WEST ELEVATION

REVISION A:

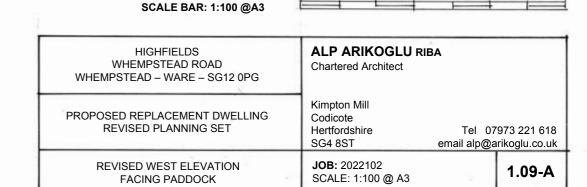
- 1: CENTRAL HIPPED ROOF CHANGED TO GABLE END
- 2: WINDOW AND FRENCH DOOR PROPORTIONS REVISED
- 3: GLAZING BARS ADDED TO ALL JOINERY
- 4: BRICK PLINTH ALTERED TO LIMESTONE TO MATCH LIMESTONE PORCH 5: BRICK WORK CHIMNEYS ADDED
- 6: LIMESTONE CILLS ADDED
- 7: WINDOW ARCHES REVISED TO CAMBERED GAUGED ARCHES 8: FIRST FLOOR SIDE WINDOW ADDED TO BEDROOM 4
